<p>OS-299 (5-21)</p>  <p>pennsylvania DEPARTMENT OF TRANSPORTATION www.penndot.gov</p>	<p>TRANSMITTAL LETTER</p>	<p>PUBLICATION: Publication 218M</p> <hr/> <p>DATE: 10/7/2024</p>
<p>SUBJECT: Standards for Bridge Design April 2016 Edition Change 7</p>		
<p>INFORMATION AND SPECIAL INSTRUCTIONS:</p> <p>Incorporate the attached revisions into the April 2016 Edition of Publication 218M.</p> <p>These revisions provide details for the connection of W-Beam Guide Rail (Type 31-S) to bridge barriers on the trailing end of bridges on divided highways and one-way roadways.</p> <p>These standards may be used immediately and can be adopted as soon as practical on all new and existing designs without affecting letting schedules and in conjunction with the current Publication 408 Specifications. Projects with T.S.&L. submissions after December 15, 2024 and projects let after April 11, 2025 must incorporate these new standards.</p> <p>A description of the changes made to the 2016 Edition since Change 6 of February 14, 2023 are listed in the attached multi-sheet Table. On the standards, light red highlighting indicates Change 7 revisions to details and notes.</p> <p>Comments or questions concerning

PA TYPE 10M BARRIER END TRANSITION WITH W-BEAM CONNECTION

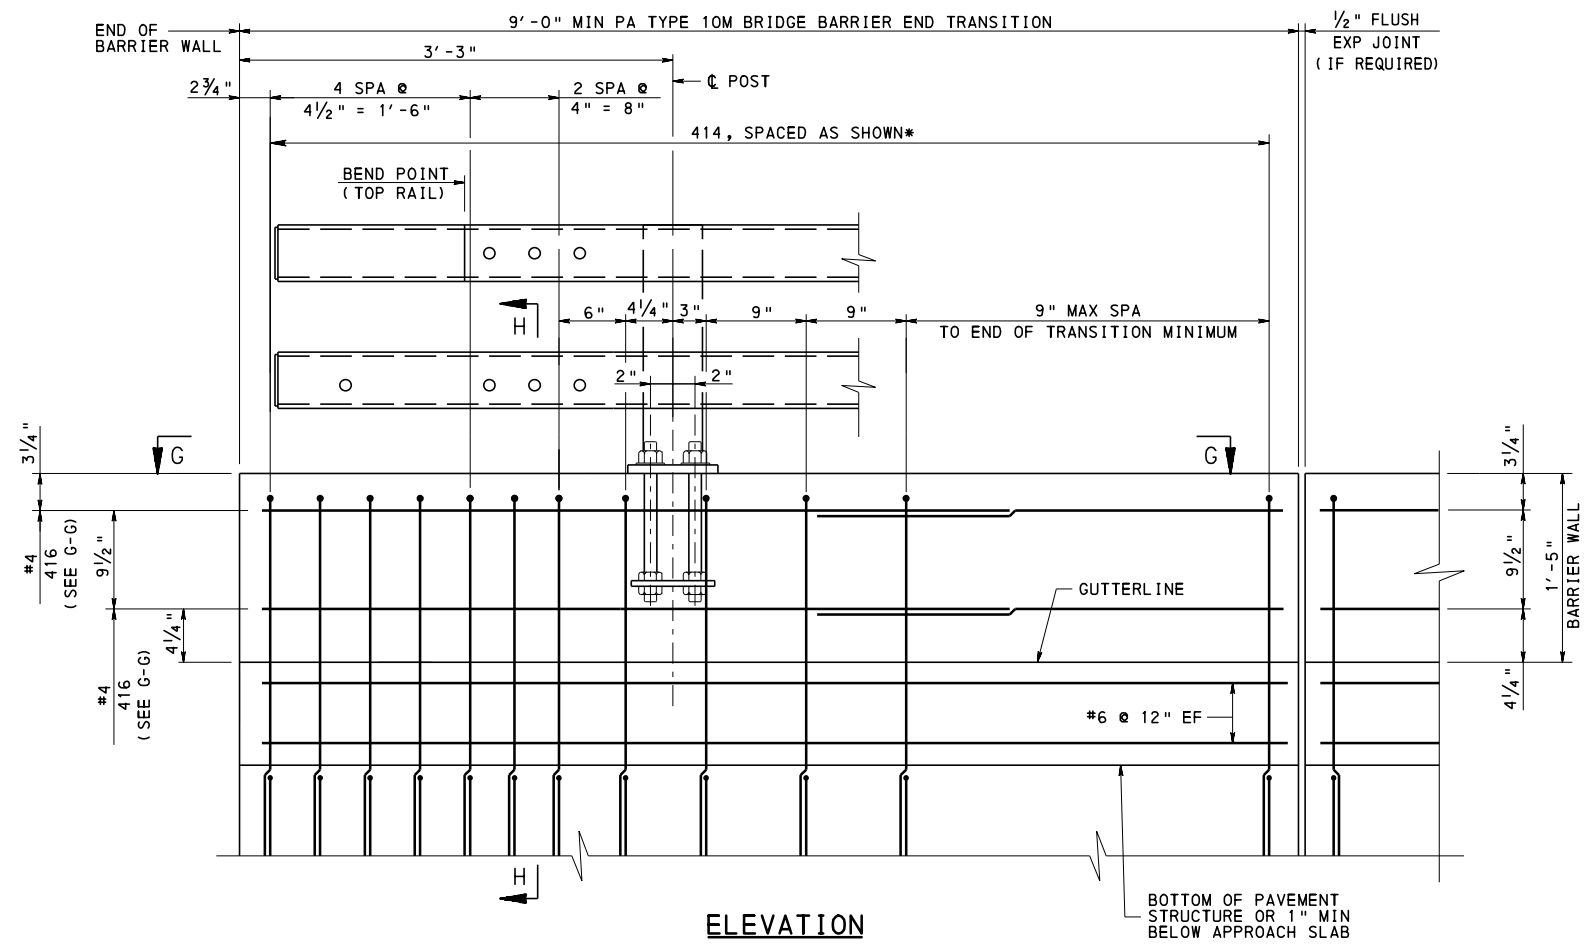
STANDARD	SHEET	DESCRIPTION OF CHANGES
BD-617M	2 of 10 (formerly 2 of 9) (cont.)	PA TYPE 10M BRIDGE BARRIER END TRANSITION: <ul style="list-style-type: none"> Added “WITH THRIE-BEAM CONNECTION” to the detail name. CLEAR ROADWAY WIDTH DETAIL: <ul style="list-style-type: none"> Added 1’-6” dimension Added “(THRIE-BEAM GUIDE RAIL SHOWN, W-BEAM GUIDE RAIL SIMILAR)” beneath detail name. Revised note from “CLEAR DECK WIDTH INCLUDES CLEAR ROADWAY WIDTH PLUS 3 3/8" ON BOTH SIDES AT THE BARRIER FOR THE THRIE-BEAM TERMINAL CONNECTOR WIDTH” to “CLEAR DECK WIDTH INCLUDES CLEAR ROADWAY WIDTH PLUS 3 3/8" MINIMUM TO ACCOUNT FOR THE THRIE-BEAM OR W-BEAM TERMINAL CONNECTOR WIDTH”.
	3 of 10 (formerly 3 of 9)	TITLE BLOCK: <ul style="list-style-type: none"> Added “WITH THRIE-BEAM CONNECTION” to sheet title.
	4 of 10 (NEW)	New Sheet – END OF BARRIER DETAILS WITH W-BEAM CONNECTION Added ELEVATION, SECTION G-G, SECTION H-H AND HORIZONTAL REINFORCEMENT, LEGEND and NOTES to show details for the W-Beam Terminal Connection.

W-BEAM
 TERMINAL CONNECTOR
 BOLT HOLE DETAIL

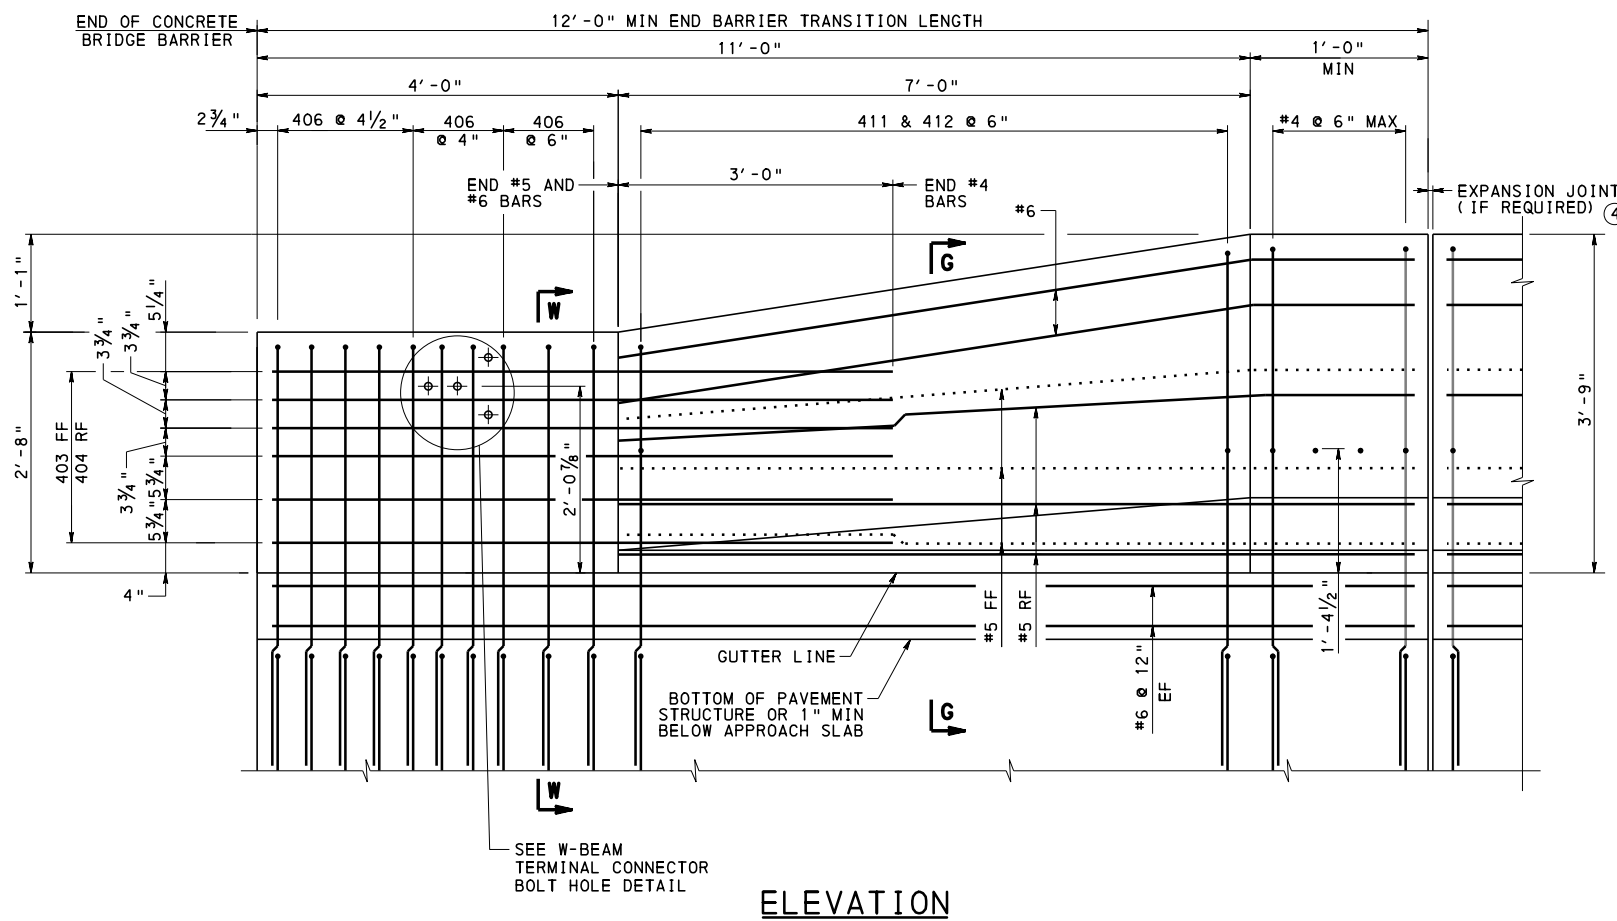
BD-622M	General	Inserted new sheets 9, 10 and 11 and renumbered subsequent sheets; updated total number of sheets and all sheet references.
	1 of 13 (formerly 1 of 10)	GENERAL NOTES: <ul style="list-style-type: none"> Added Notes 4, 5 and 6. REFERENCE DRAWINGS: <ul style="list-style-type: none"> Added RC-51M – TYPE 31 STRONG POST GUIDE RAIL.
	2 of 13 (formerly 2 of 10)	SECTION C-C and ALTERNATE SECTION C-C: <ul style="list-style-type: none"> Added "3" next to the bar callouts located in the last 4' of the section. Added callout "END CHAMFERS (SEE SHEET 1, GENERAL NOTE 6)". Revised "OPTIONAL CONSTR. JT. AT BOTTOM OF PAVEMENT STRUCTURE OR 1" BELOW APPROACH SLAB" to "OPTIONAL CONSTR JT AT BOTTOM OF PAVEMENT STRUCTURE OR 1" MIN BELOW APPROACH SLAB" SECTIONS D-D, E-E and F-F: <ul style="list-style-type: none"> Revised "BOTTOM OF PAVEMENT STRUCTURE OR 1" BELOW APPROACH SLAB" to "BOTTOM OF PAVEMENT STRUCTURE OR 1" MIN BELOW APPROACH SLAB" LEGEND: <ul style="list-style-type: none"> Added Legend Note "3".

**STANDARD
BRIDGE APPROACH SLABS
TYPE 1 AND TYPE 2 - PLAN 1**

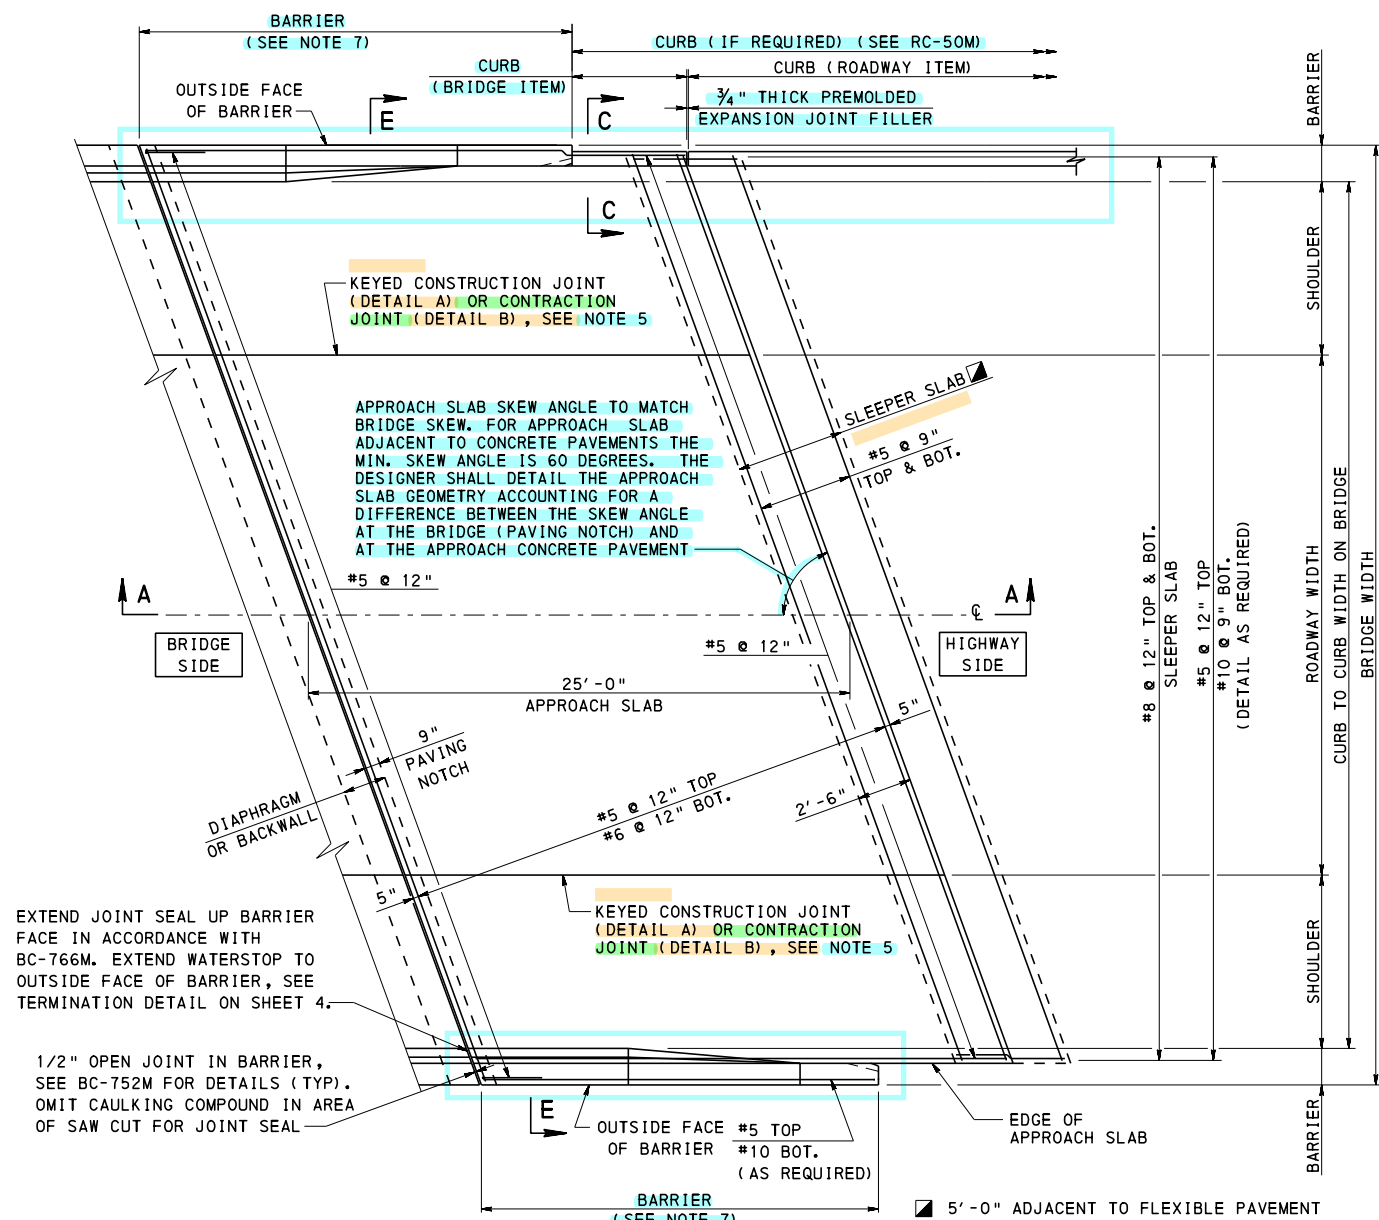
OLD 4 of 36 NEW 4 of 35	<p>TITLE BLOCK:</p> <ul style="list-style-type: none"> Revised “SHEET 4 OF 36” to “SHEET 4 of 35” <p>PLAN 1 TYPE 1 AND 2:</p> <ul style="list-style-type: none"> Left barrier: Removed 10° flare and revised for MASH barrier end transition with curb. Revised “1” FLUSH EXPANSION JOINT” to “¾” THICK PREMOLDED EXPANSION JOINT FILLER”. Right barrier: Removed 10° flare and revised for MASH barrier end transition without curb. Revised “(LENGTH AS REQUIRED)” to “SEE NOTE 6 & 7” (2 locations). Removed “10’-0” MIN.” dimension and “BEND LINE” callouts (2 locations). Removed “8” CURB” and 8¾” dimension. Revised “APPROACH SLAB SKEW ANGLE TO MATCH BRIDGE SKEW” to “APPROACH SLAB SKEW ANGLE TO MATCH BRIDGE SKEW. FOR APPROACH SLAB ADJACENT TO CONCRETE PAVEMENTS THE MINIMUM SKEW ANGLE IS 60 DEGREES. THE DESIGNER SHALL DETAIL THE APPROACH SLAB GEOMETRY ACCOUNTING FOR A DIFFERENCE BETWEEN THE SKEW ANGLE AT THE BRIDGE (PAVING NOTCH) AND AT THE APPROACH CONCRETE PAVEMENT.”. <p>TYPE 2 APPROACH SLAB ADJACENT TO MOMENT SLAB:</p> <ul style="list-style-type: none"> Revised “SEAL WITH ASPHALT JOINT SEALANT (AC-20)” to “SEAL WITH ASPHALT RUBBER SEALING COMPOUND [PUB. 408, SECTION 705.4(g)].” <p>NOTES:</p> <ul style="list-style-type: none"> Note 6: Removed.

STANDARD	SHEET	DESCRIPTION OF CHANGES
BD-628M (cont.)	OLD 4 of 36 NEW 4 of 35 (cont.)	<ul style="list-style-type: none"> Note 7: Removed. Added new note – “6. 45” F-SHAPE CONCRETE BARRIER IS NOT PERMITTED ON MOMENT SLABS.”. Added new note – “7. LENGTH AS REQUIRED FOR THE SELECTED BARRIER, 16’-0” MINIMUM PER BD-627M.”. Added new note – “8. FOR ADDITIONAL BARRIER END TRANSITION DETAILS, SEE BD-601M, BD-610M, BD-617M, BD-618M, BD-622M, BD-624M AND RC-50M.”.
	OLD 5 of 36 NEW 5 of 35	<p>TITLE BLOCK:</p> <ul style="list-style-type: none"> Revised “SHEET 5 OF 36” to “SHEET 5 of 35” <p>PLAN 2 TYPE 1 AND 2:</p> <ul style="list-style-type: none"> Left barrier: Removed 10° flare and revised for MASH barrier end transition with curb. Moved outside edge of approach slab and sleeper slab to end at rear face of curb. Revised “1” FLUSH EXPANSION JOINT” to “¾” THICK PREMOLDED EXPANSION JOINT FILLER”. Revised curb callouts. Right barrier: Removed 10° flare and revised for MASH barrier end transition without curb. Moved outside edge of approach slab and sleeper slab to end at front face of barrier. Revised “SHEET 7” to “SHEET 5” (4 locations). Revised “APPROACH SLAB SKEW ANGLE TO MATCH BRIDGE SKEW” to “APPROACH SLAB SKEW ANGLE TO MATCH BRIDGE SKEW. FOR APPROACH SLAB ADJACENT TO CONCRETE PAVEMENTS THE MINIMUM SKEW ANGLE IS 60 DEGREES. THE DESIGNER SHALL DETAIL THE APPROACH SLAB GEOMETRY ACCOUNTING FOR A DIFFERENCE BETWEEN THE SKEW ANGLE AT THE BRIDGE (PAVING NOTCH) AND AT THE APPROACH CONCRETE PAVEMENT.”. <p>TYPE 2 – CONCRETE APPROACH SLAB WITH SUPERPAVE ASPHALT OVERLAY:</p> <ul style="list-style-type: none"> Revised 1” to ½”. Revised 8” to 4”. Revised detail for 4” curb. Revised “SEAL WITH ASPHALT JOINT SEALANT (AC-20)” to “SEAL WITH ASPHALT RUBBER SEALING COMPOUND [PUB. 408, SECTION 705.4(g)].”. <p>TYPE 1, 3, OR 5 – CONCRETE APPROACH SLAB:</p> <ul style="list-style-type: none"> Revised 7” to 7½”. Revised 1” to ½”. Revised 8” to 4”. Revised detail for 4” curb. Revised “SEE NOTE 6” to “SEE NOTE 4”. <p>JOINT SEALING DETAIL:</p> <ul style="list-style-type: none"> Revised “SEE NOTE 8” to “SEE NOTE 6”.

GRS CAUTION TAPE (PLAN VIEW)

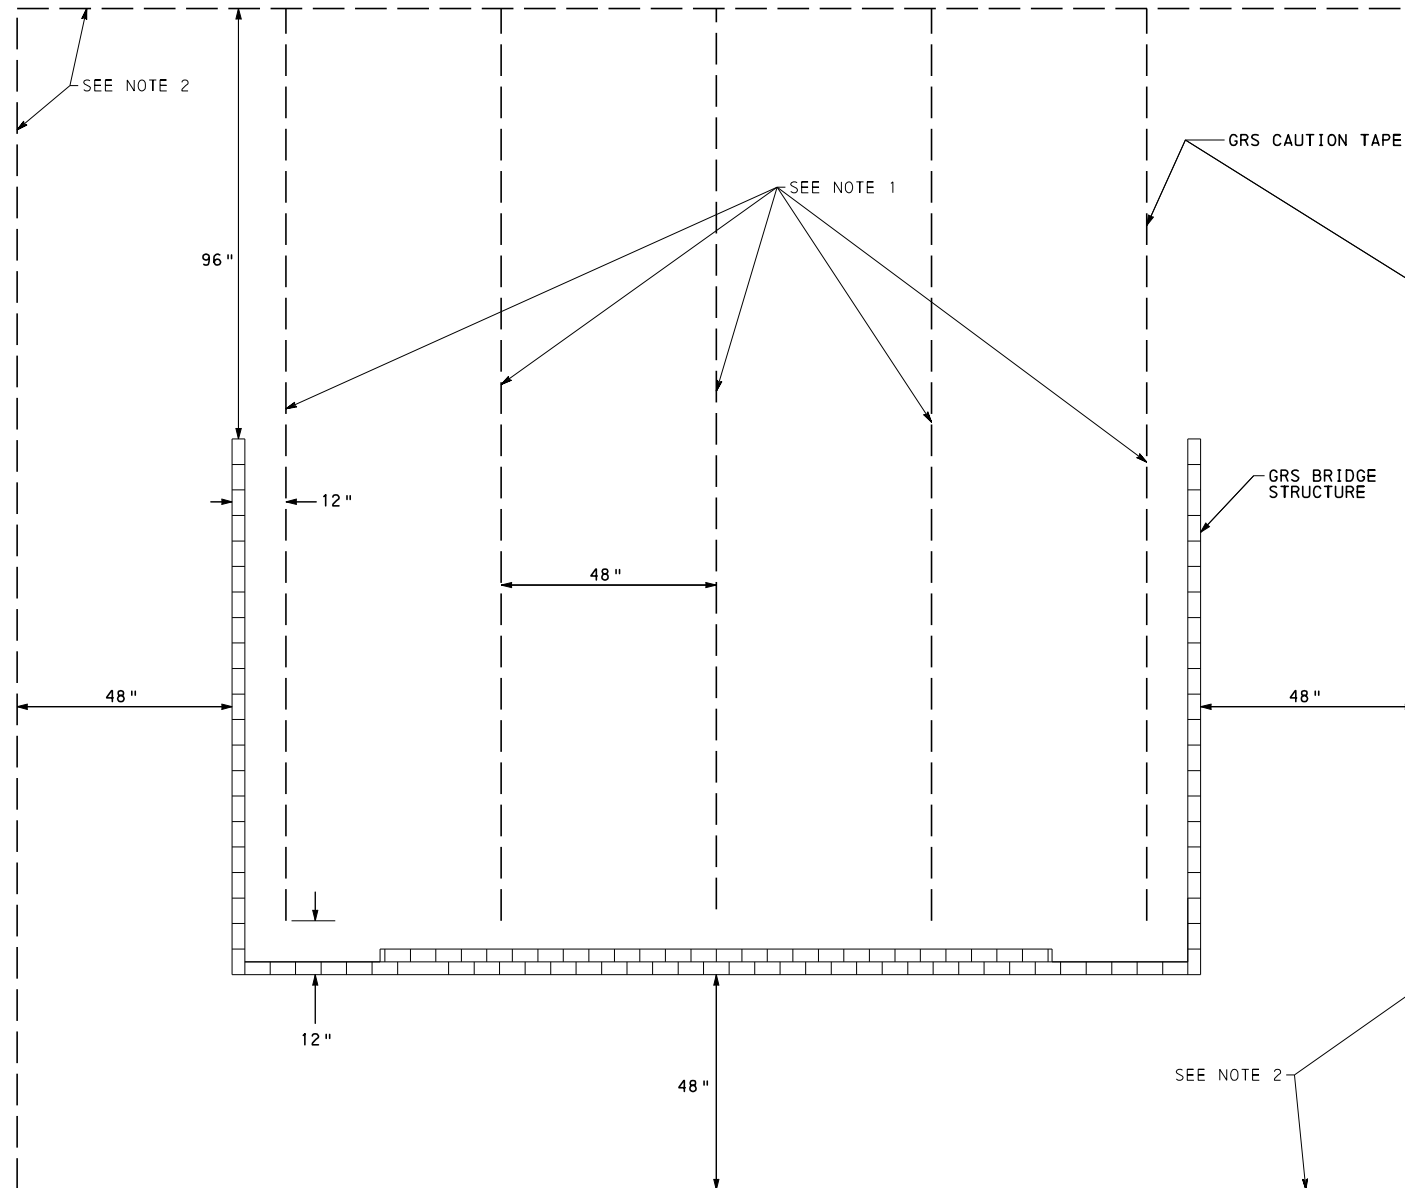
BD-697M	5 of 5 (NEW)	Added sheet 5 for GRS-IBS Caution Tape Placement. [e-Notification No. 77, dated 12/21/2020]
		NOTE 3: Modified and provided additional caution tape requirements. Removed image of caution tape.
